Bryant Development and Review Committee Meeting

Date: July 31, 2025 - **Time:** 9:00 AM

6. New Beginnings - Hwy 5 and Midland Rd

PLE - Requesting Site Plan Approval

OVERALL
SITE PLAN

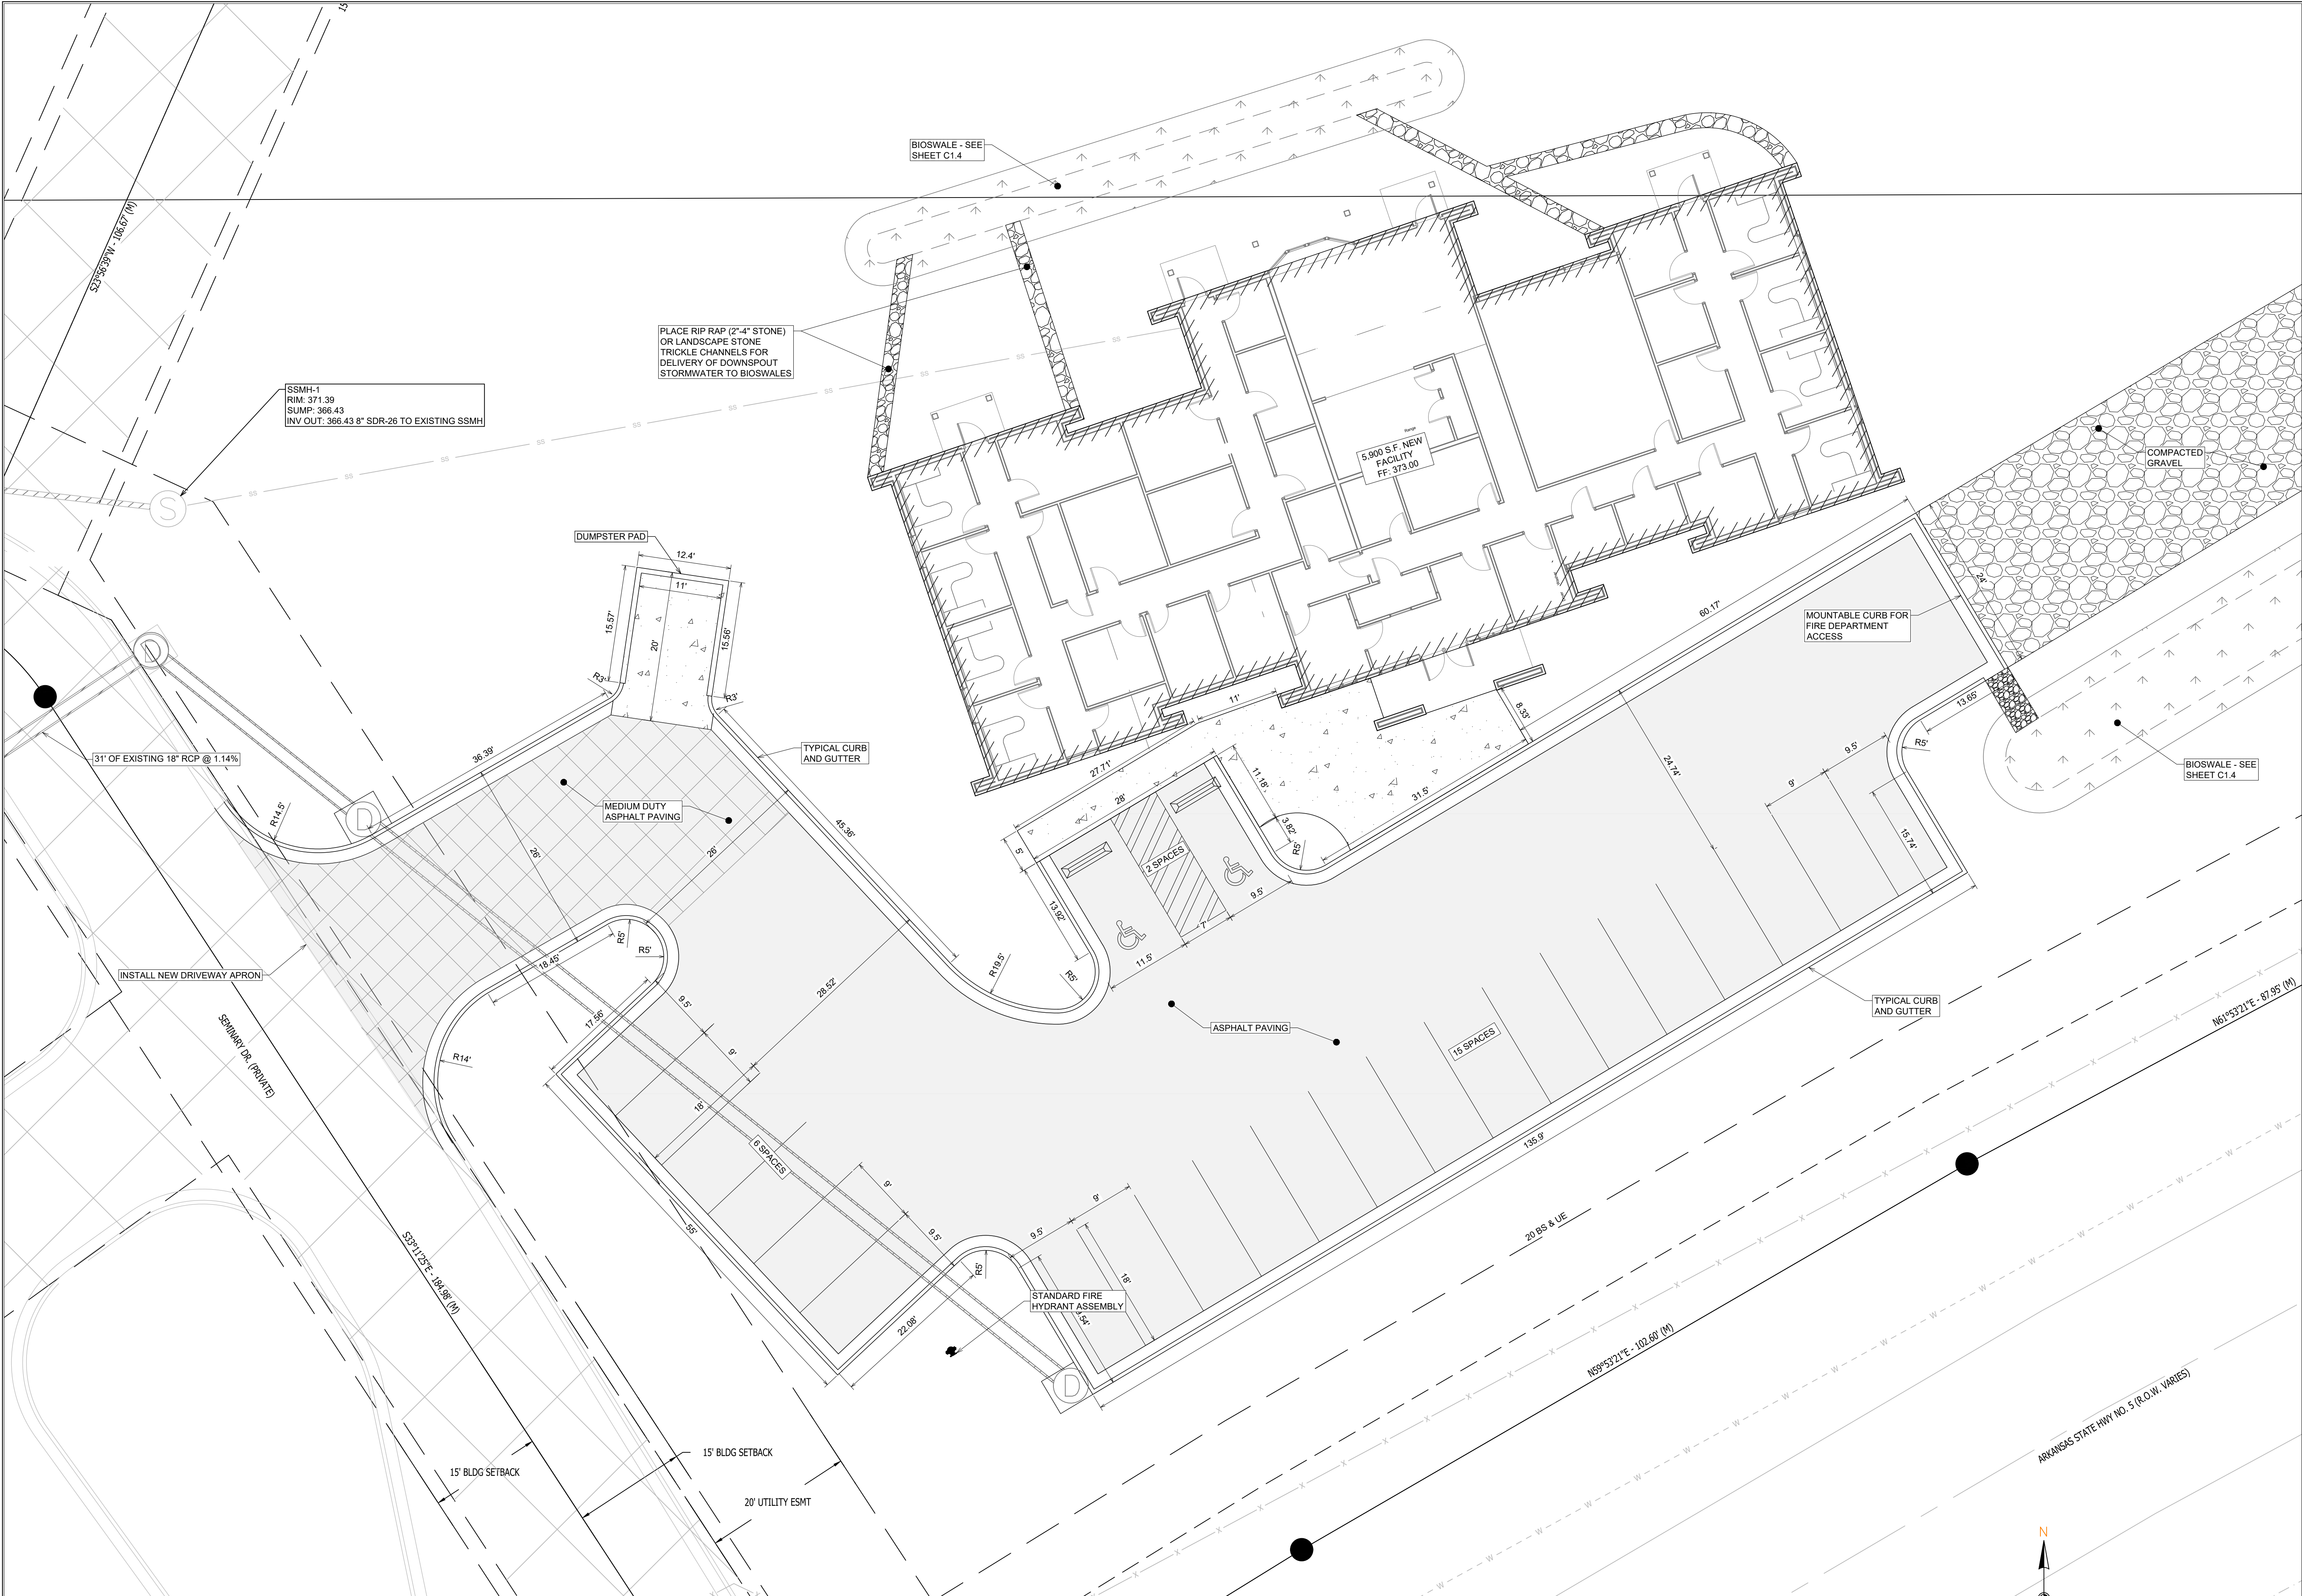
3. Drawing C1.1
- a. Add labels indicating improvements
 - Improvements and existing items are now more clearly shown.
 - b. Add legend??
 - Added.
4. Drawing C1.2

PROJECT NUMBER:
SHEET ISSUE DATE: 07-24-2025
PAGE TITLE:
GRADING PLAN
SHEET NUMBER:
C1.4

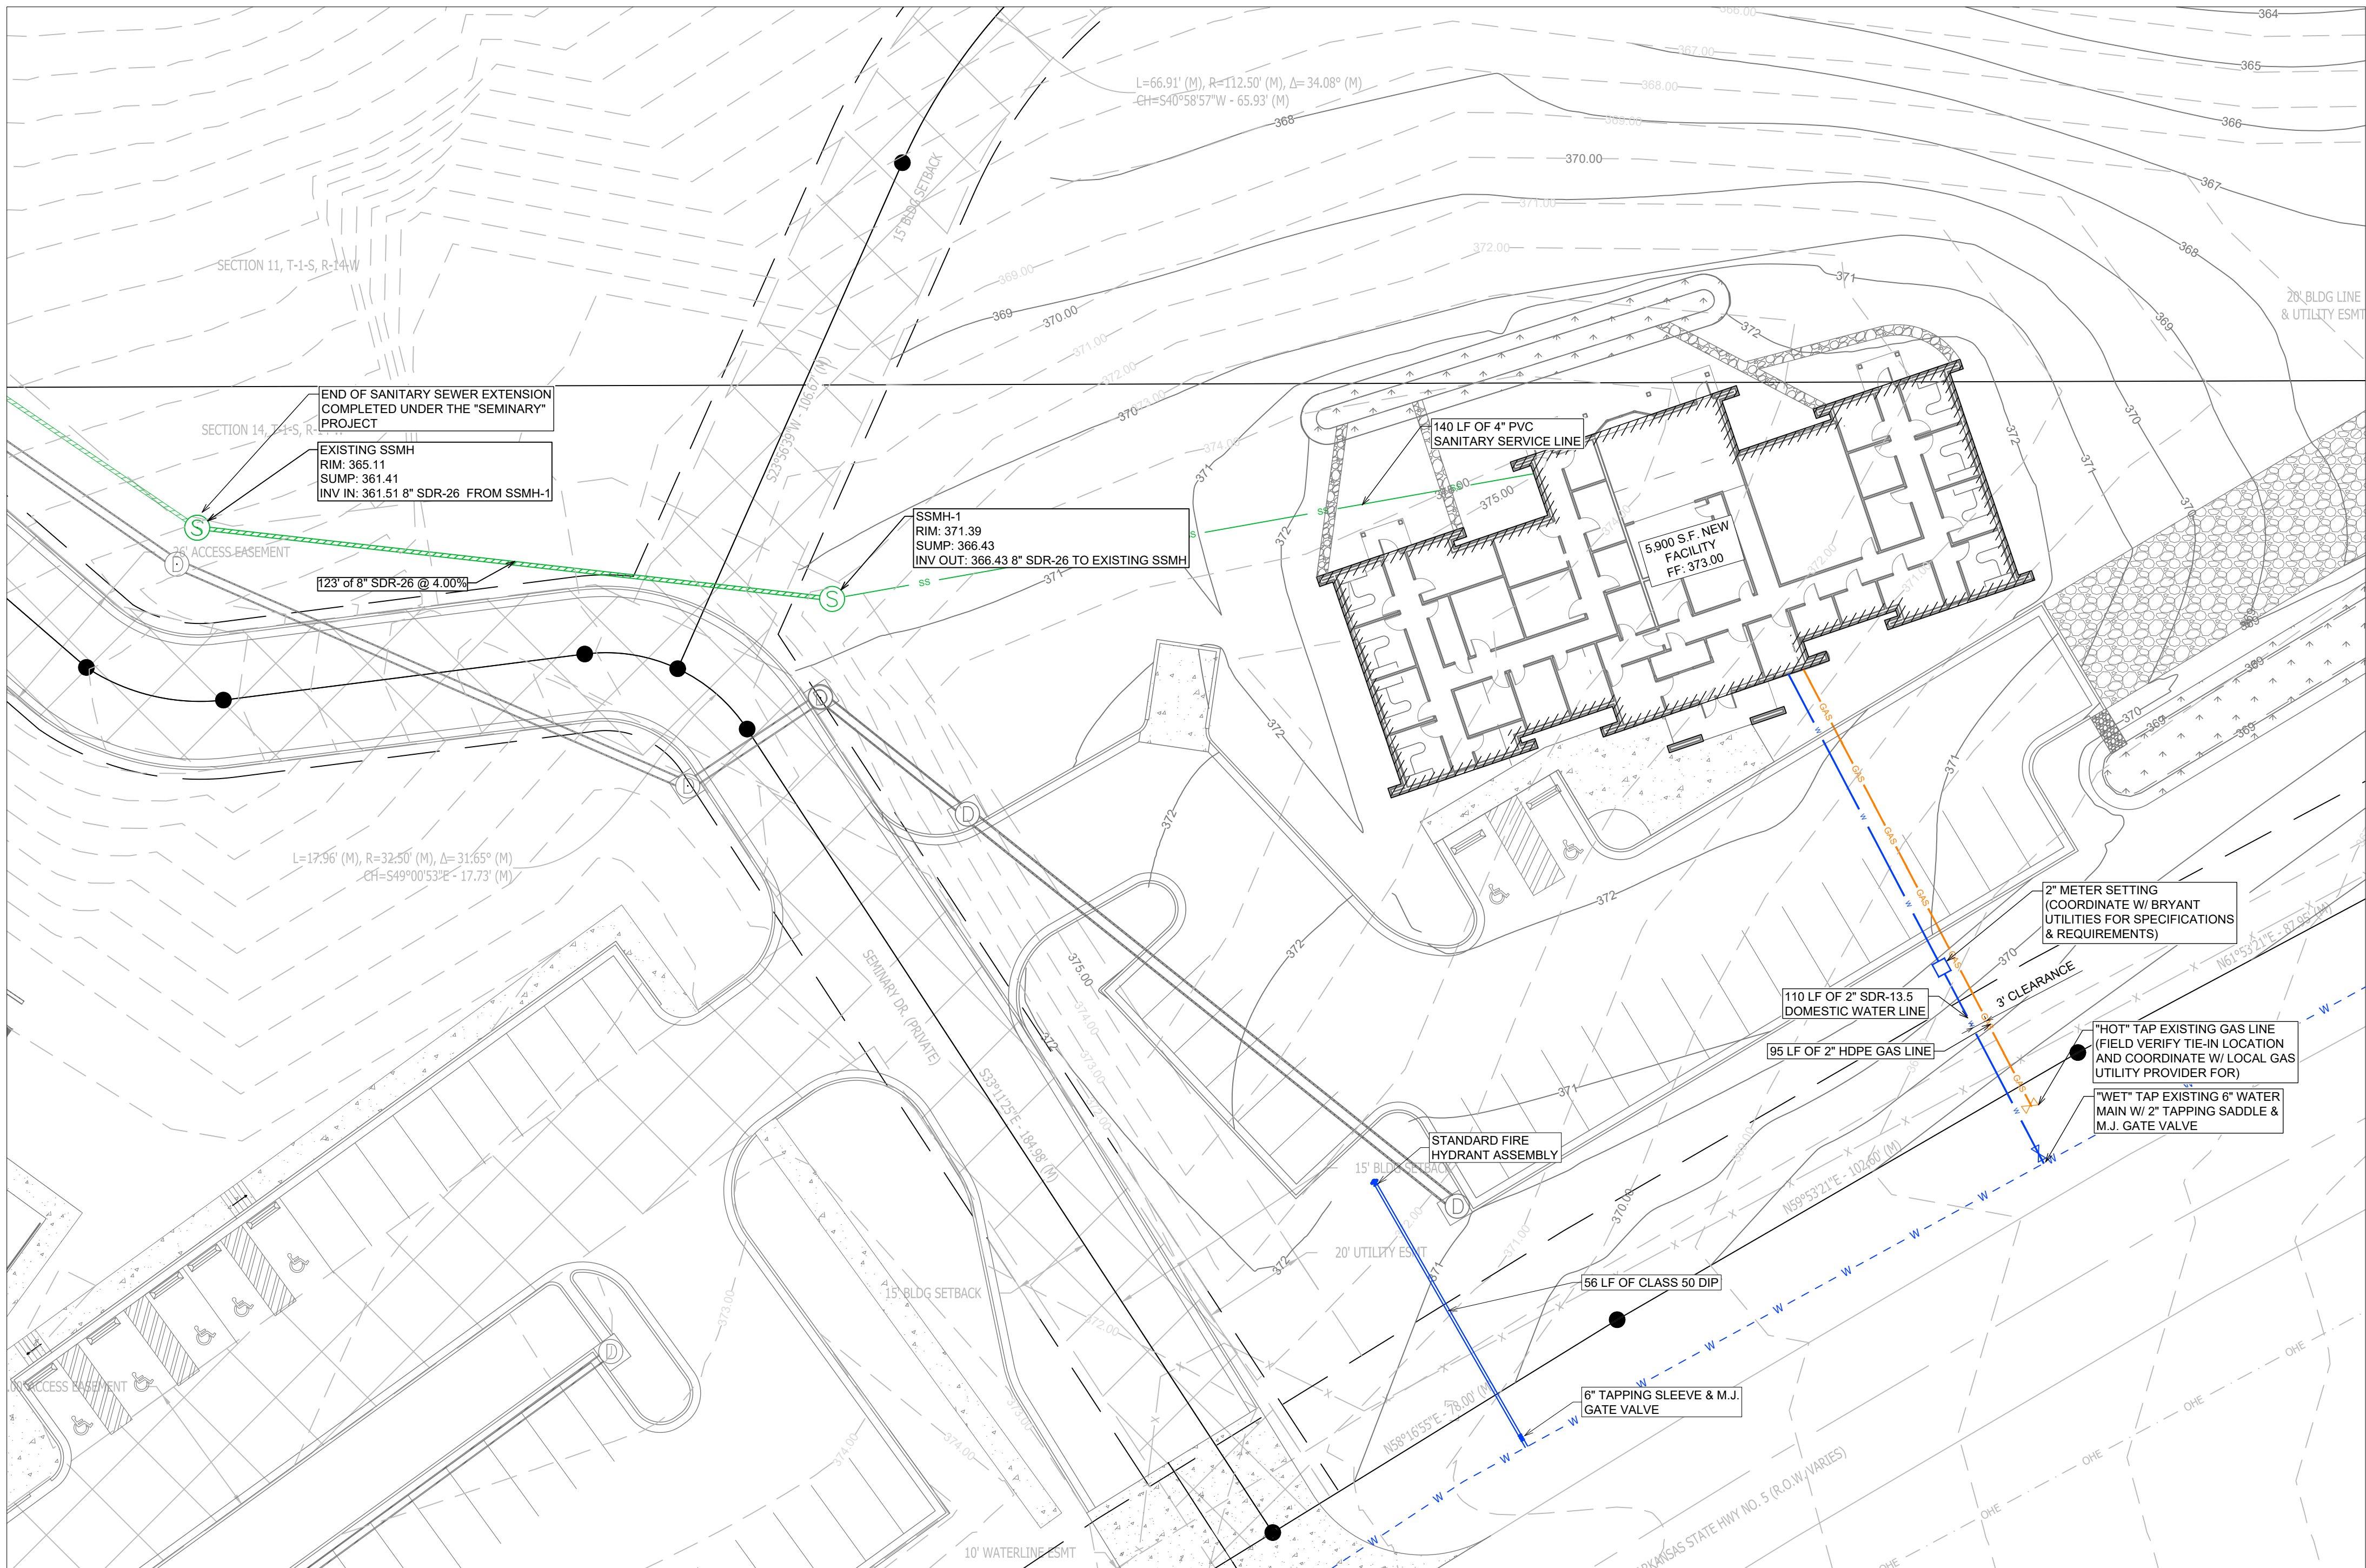
- Note has been revised on the ADA sign detail.
6. Drawing C1.4
- a. Add labels to improvements for clarity.

- i. Label dumpster
 - Corrected
7. Drawing C1.5
- a. Add labels for clarity
 - Labels have been added.
 - b. Show detail of curb cut
 - c. Provide scour / erosion protection downstream from the curb cut
